Errata- StationPro II Operating and Assembly Manual

(revised 10-08-2012 – additions & corrections to manual version 5/07/2010)

Page 45:

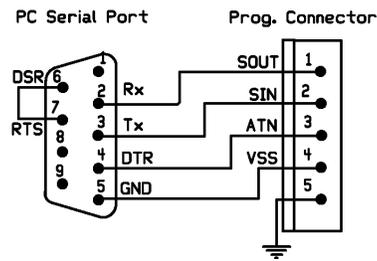
In Step (e), the drawing has the retaining clip shown on the wrong side of the program connector. Please correct the drawing or replace it with the following. (Note that the numbers are as viewed from the rear side of the connectors, e.g., the side that the cable emerges from.)
